ECE/TRANS/WP.29/GRSG/2009/2
3 February 2009

REGULATION No. 107 (M₂ and M₃ vehicles)

Proposal for further amendments

Submitted by the expert from the International Organization of Vehicle Manufacturers */

"Figure 5

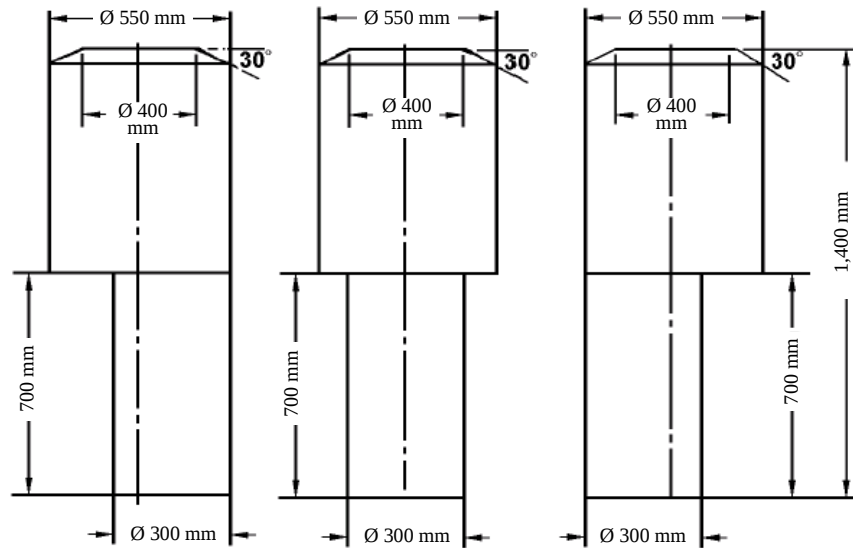
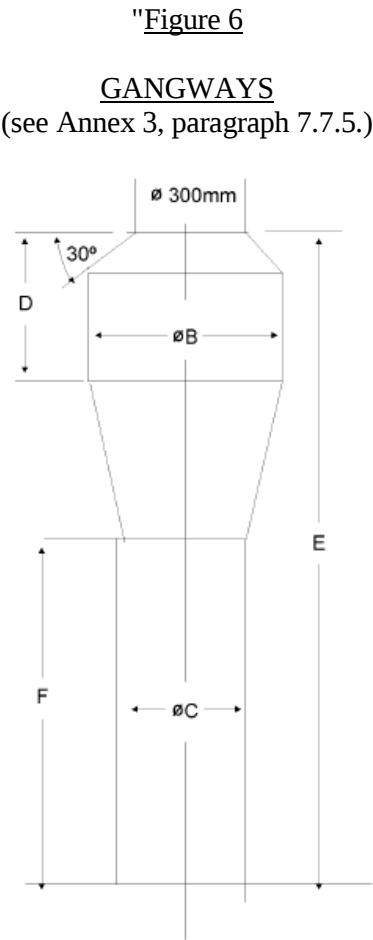
Figure 5. amend to read:

The base of the first cylinder shall be within the projection of the second cylinder. "

To add footnote which is moved from Annex 3, paragraph 7.7.2.2.

"Figure 8

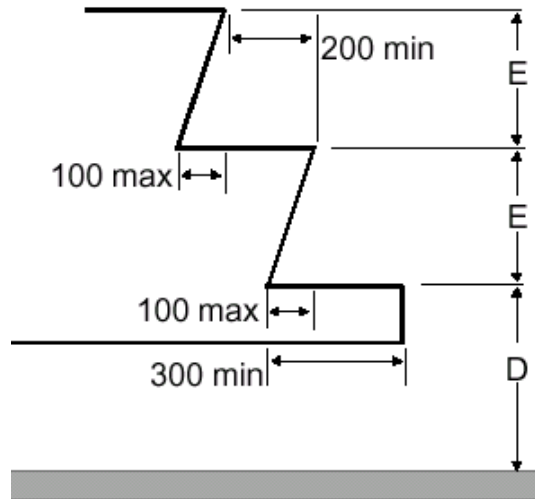
Figure 8, amend to read:

(*) 230 mm for vehicles **of Class A or B** ~~having a capacity not exceeding 22 passengers.~~

(4) 250 mm in gangways for vehicles **of Class A or B** ~~having a capacity not exceeding 22 passengers.~~

Standardisation on Class of vehicles and not on the number of passengers.
